Access Compliance Report Public Rights-of-Way (Curb Ramps)

Main Street: RESTON_WAY Cross Street: BARNSTABLE_WAY Location: W

ADA ID: RPRK211101125916 Ramp Type: Type 4 - Parallel Initial Pass/Fail: Fail Overall Compliance: No Severity Score: 16

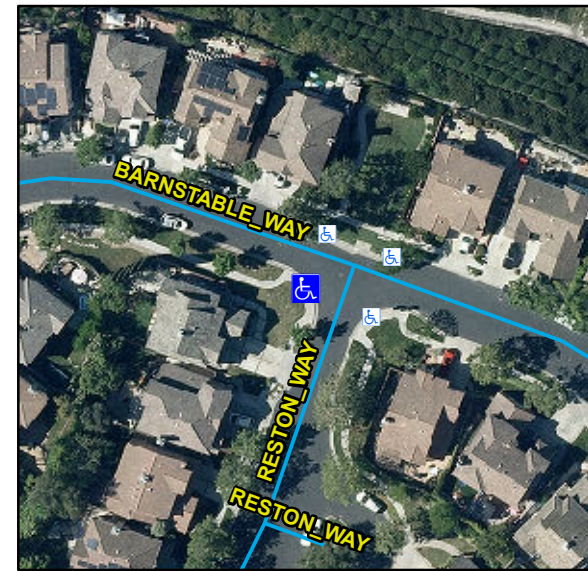
Compliance	Description	Data	Compliance	Description	Data
N/A	Ramp Length LT (in)	106	N/A	Ramp Length RT (in)	108
Yes	Ramp Width LT (in)	48	Yes	Ramp Width RT (in)	48
Yes	Ramp Run Slope LT (%)	3.6	No	Ramp Run Slope RT (%)	11.8
No	Ramp Cross Slope LT (%)	2.6	Yes	Ramp Cross Slope RT (%)	0.8
N/A	Landing Present	N/A	N/A	DWS Provided	N/A
N/A	Landing Length (in)	N/A	N/A	DWS Contrast	N/A
N/A	Landing Width (in)	N/A	N/A	DWS Length (in)	N/A
N/A	Landing Run Slope (%)	N/A	N/A	DWS Full Width	N/A
N/A	Landing Cross Slope (%)	N/A		DWS Offset Type	N/A
N/A	Landing Movement Obstructed?	N/A	N/A	DWS Offset Left (in)	N/A
	Landing Movement Type	N/A	N/A	DWS Offset Right (in)	N/A
N/A	Landing Shared	N/A			
N/A	Clear Space	Yes			
N/A	Clear Space To Crosswalk (in)	N/A			
N/A	Marked Crosswalk 1	No	N/A	Marked Crosswalk 2	No
	Crossing 1 Direction	SE		Crossing 2 Direction	NE
N/A	Marked Crosswalk 1 Width (in)	N/A		Marked Crosswalk 2 Width (in)	N/A

Remove & Replace Curb Ramp With Two New Directional Ramps or Equivalent.

R204.3, R304.5.3, R304.3.2, STD 1115
